MONTICELLO NUCLEAR GENERATING PLANT
Docket No. 50-263 License No. DPR-22

Supplemental Report of a Change in the
Transient Analysis as Described in the FSAR

RESULTS OF TRANSIENT REANALYSES FOR MONTICELLO NUCLEAR GENERATING PLANT WITH END-OF-CYCLE CORE DYNAMIC CHARACTERISTICS

FIGURE 1. SCRAM REACTIVITY CURVES — MONTICELLO

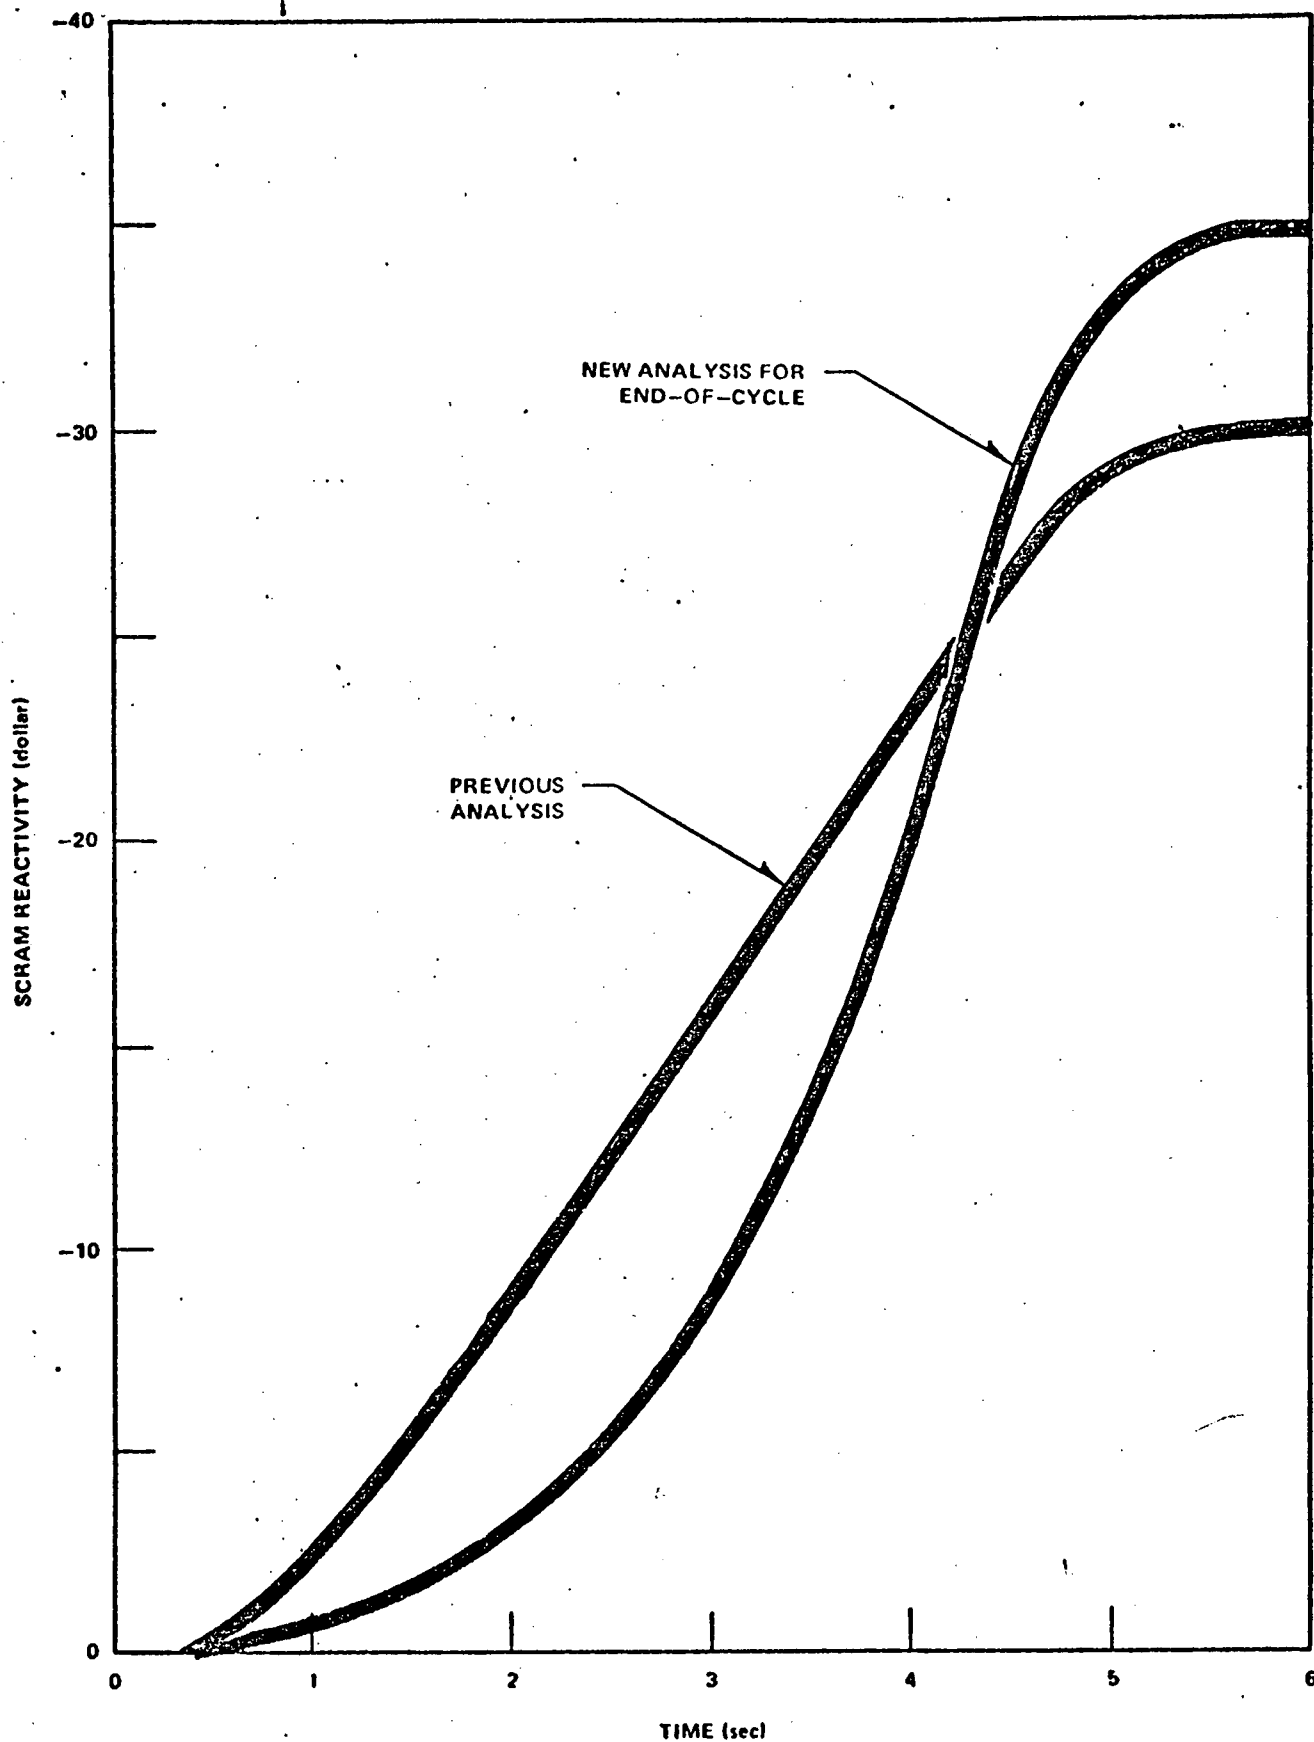
A recent reanalysis has shown that a significant change in the shape of the scram reactivity curve could occur by the end of a fuel cycle (see fig.1). As can be seen, even though the total scram reactivity has increased somewhat, the insertion rate is slower at the beginning of the stroke where the transient analyses described in the FSAR for single-event caused abnormal occurrences could be affected. This, in turn, could affect design, operational, and safety provisions derived from these analyses for such things as the relief and safety valve capacities, set points, and Technical Specification requirements. For this reason, all transient analyses previously performed for Monticello have been reviewed, those which affect relief and safety valve settings and capacity have been redone, and necessary Technical Specification revisions determined.

FIGURE 2. CONTROL ROD DRIVE SCRAM TIMES — MONTICELLO

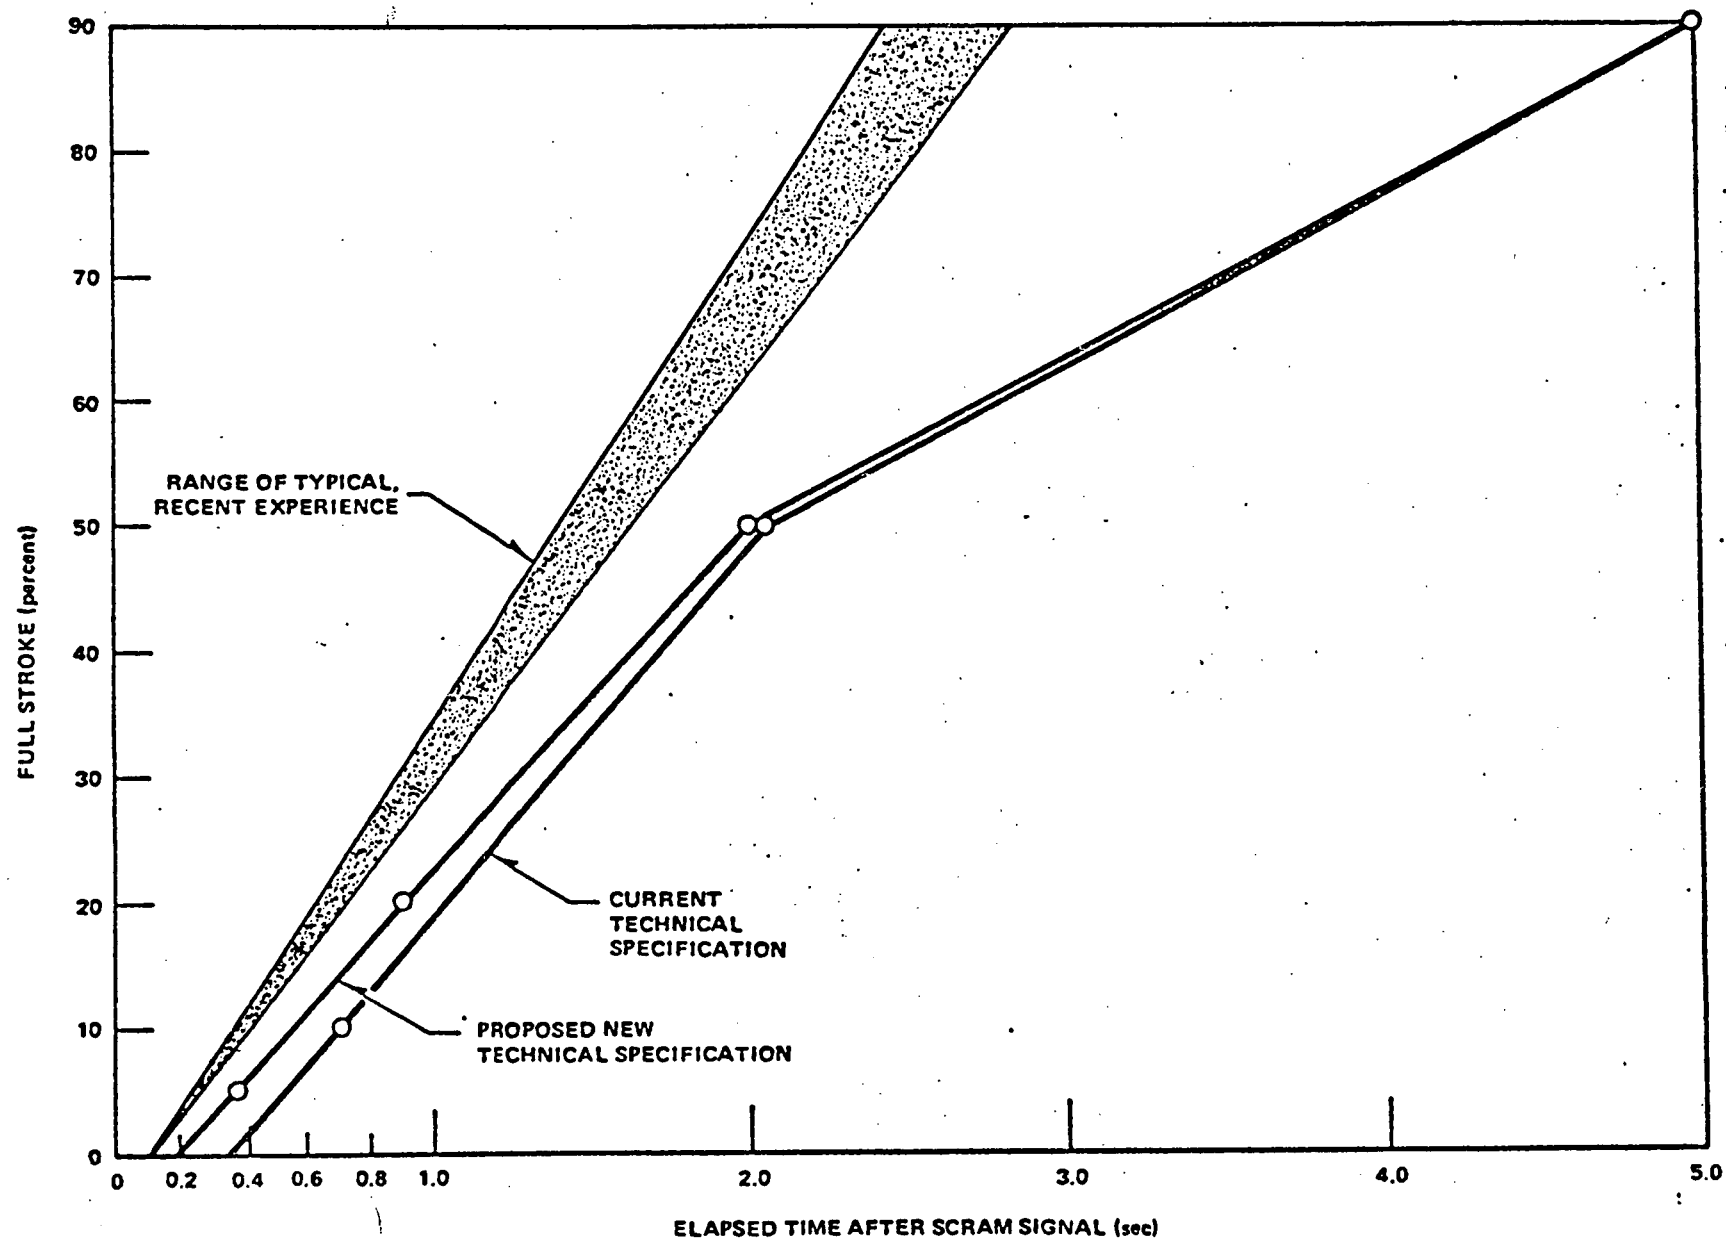
When the analyses were completed, all the design guidelines, margins, criteria, etc. were met with the exception of the relief valve adequacy transient (turbine trip without bypass). In this case, the margin from the peak of the pressure transient to the setting of the first safety valve was not sufficient to meet the General Electric recommended design guideline minimum of 25 psi. In order to meet this guideline, a slight improvement in the control rod drive scram time was assumed, to that being used on the '67 and later GE-BWR Product Line plants (see Fig. 2). With the improved scram time assumption, the calculated margin was 27 psi, which is acceptable.

The control rod drive equipment is the same at Monticello as at later plants and is easily capable of meeting the improved scram time requirement, as illustrated in Figure 2. As can be seen, the improvement is in the early part of the scram stroke where it can be of most benefit to the results of the transient analyses.

<u>ITEM</u>	<u>LOCATION</u>	<u>CHANGE</u>	<u>REASON</u>
Basis statement for 3.1	Pg.39 first para.	in the sixth and seventh line delete reference to the FSAR and reference this analysis	This transient has been reanalyzed and the results are presented in this analysis
	Pg.39 Third para.	in the last line delete reference to the FSAR and reference this analysis	This transient has been reanalyzed and the results are presented in this analysis
Spec 3.3.C.1	Table On Pg. 79	Change to the following:	The transient reanalyses were done with these new scram time requirements
		<u>% Inserted From Fully Withdrawn</u>	<u>Average Scram Insertion Time (secs)</u>
		5	0.375
		20	0.900
		50	2.00
		90	5.00
Spec. 3.3.C.2	Table on Pg. 79	Change to the following:	The transient reanalyses were done with these new scram time requirements.
		<u>% Inserted From Fully Withdrawn</u>	<u>Average Scram Insertion Time (secs)</u>
		5	0.398

20	0.954
		50	2.120
		90	5.300
Basis statement for 3.3 and 4.3	Pg 82, A.1 First para.	in the eleventh line, change the reference to refer to this analysis	This is in conjunction with the new scram reactivity curve used in this analysis
	Pg 85 para. C	starting in the eighth line, change "turbine stop valve closure" to-closure of the main steam isolation valves	This is consistent with the results of this new analysis
		in the eleventh line, change 1.9 to 1.8	This is consistent with the results of this new analysis

FIGURE 3.

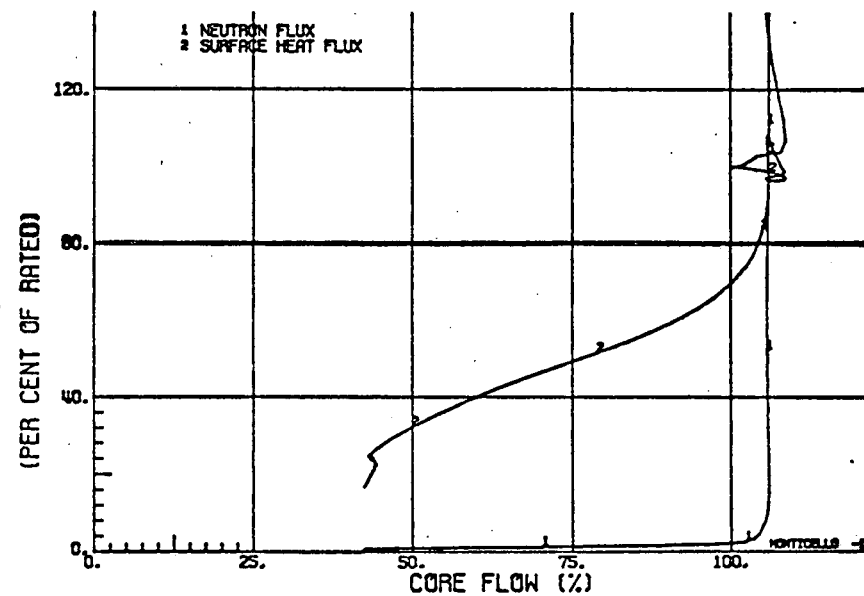
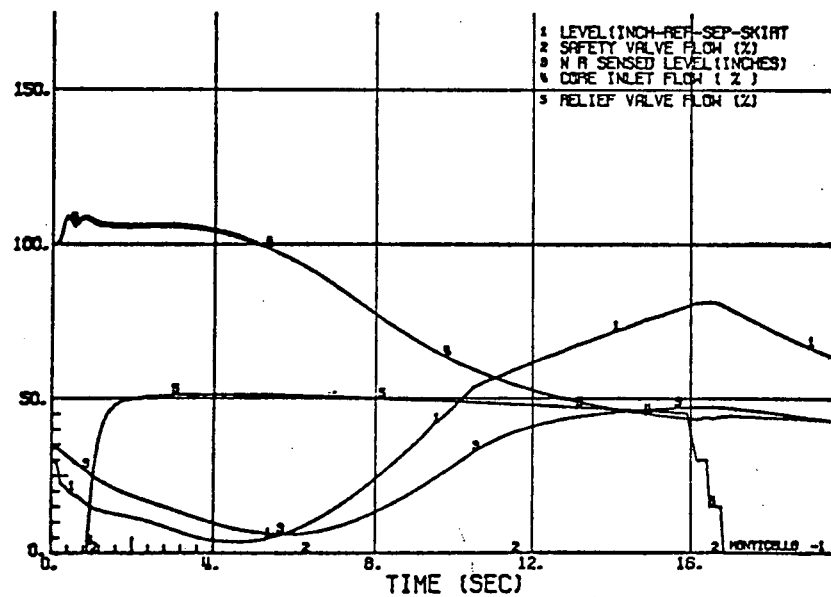
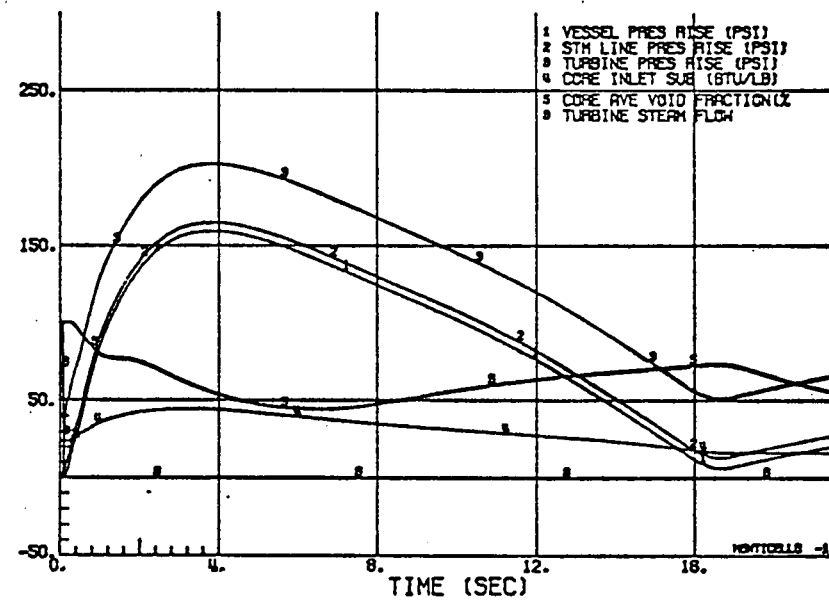
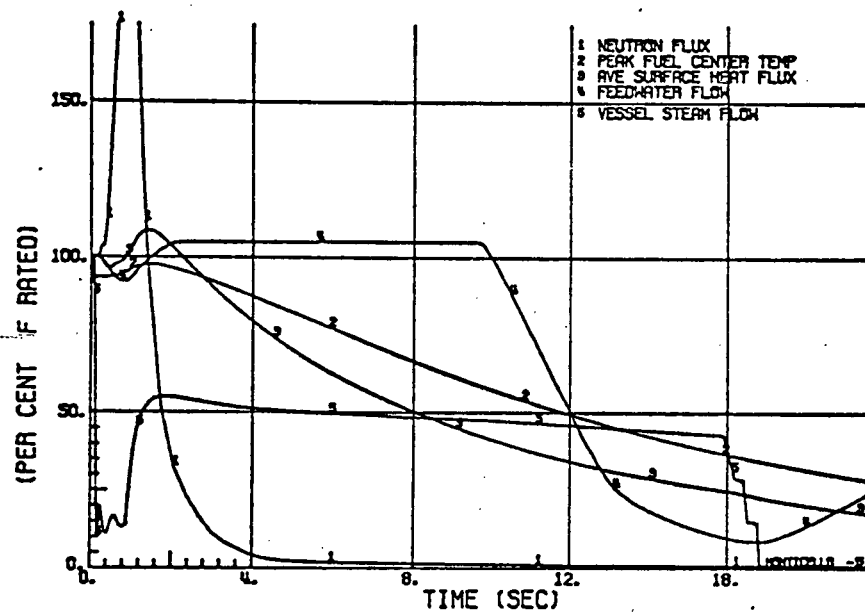
A scram signal is initiated at the same time a turbine trip occurs by position switches on the turbine stop valves. This transient causes a rapid pressure increase in the reactor pressure vessel. Primary system relief valves are provided to remove sufficient energy from the reactor to prevent safety valves from lifting. The initial reanalysis showed that peak pressure in the steam line at the safety valve location did not meet the GE margin of 25 psi to the safety valve set point. Hence, the transient was reanalyzed using the improved control rod drive scram time assumption discussed previously and illustrated in Figure 2. The results are shown in Figure 3. The peak pressure in the steam line at the safety valve location was 1183 psig, which provided an adequate margin of 27 psi to the first safety valve set point. Thus, the adequacy of the four relief valves was confirmed for these conditions. Using the parameters associated with the end of life conditions, four relief/safety valves are required to operate to prevent this pressure transient from exceeding the safety valve set point. The rapid pressure rise due to rapid closure (0.10 sec.) of the turbine stop valve without bypass operation causes core voids to collapse and neutron flux reaches 241 percent of design (Figure 3) before the scram shuts down the reactor. Peak surface heat flux is less than 110 percent (Figure 3) thus adequate thermal margins are maintained.

FIGURE 4

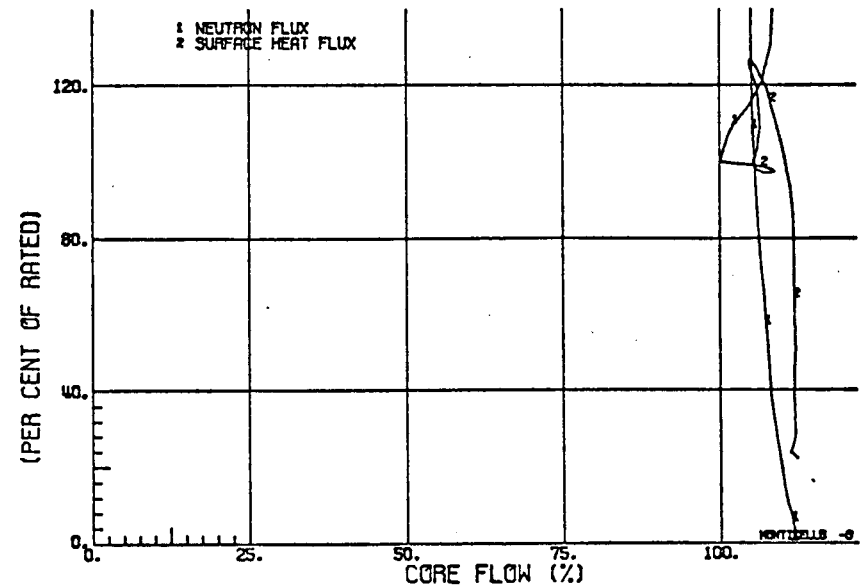
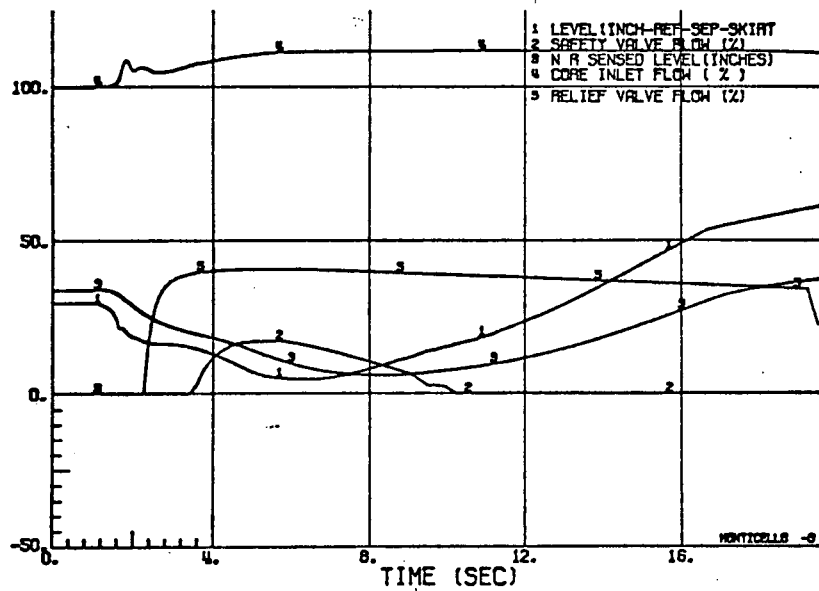
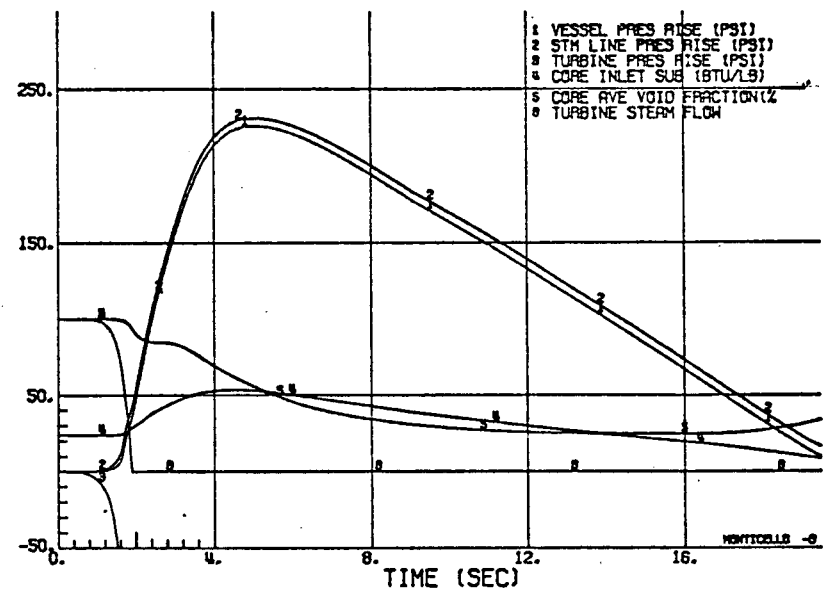
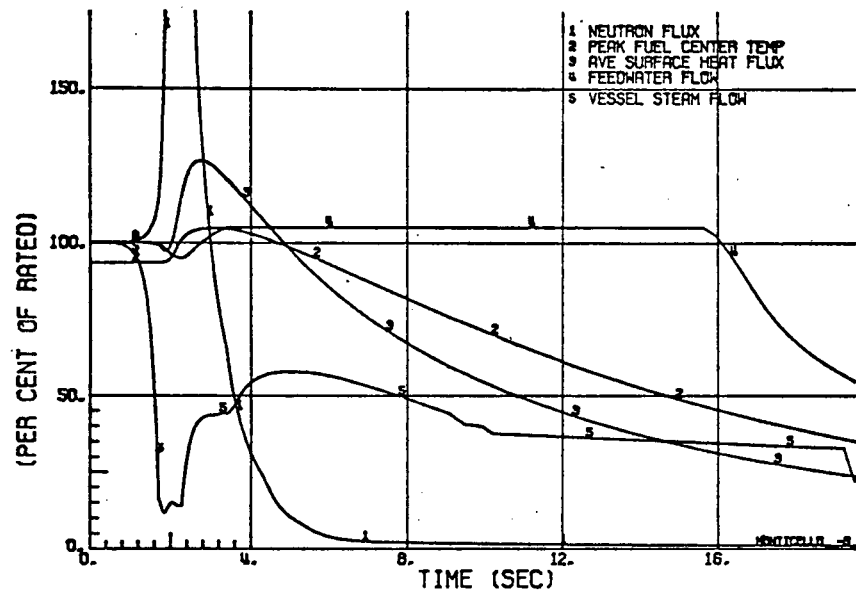
Figure 4 shows the resulting transient assuming the capacity of only 3 of the 4 relief/safety valves (35% of main steam generation rate) and only 2 of the 4 safety valves (18% of main steam generation rate). An abrupt pressure and power rise occur as soon as the isolation becomes effective. Neutron flux reaches scram at approximately 1.8 seconds initiating reactor shutdown. It peaks at a value of 610 percent. Peak fuel surface heat flux is slower, reaching a peak of 127 percent at about 27 seconds. The assumed safety valve capacity (Target Rock plus spring safety capacities) keeps the peak vessel pressure 92 psi below the peak allowable ASME overpressure of 1375 psig. Therefore, the relief valves plus the spring safety valves provide adequate protection against excessive overpressurization of the nuclear system process barrier with a large margin, because of the reduced capacities assumed for this analysis.
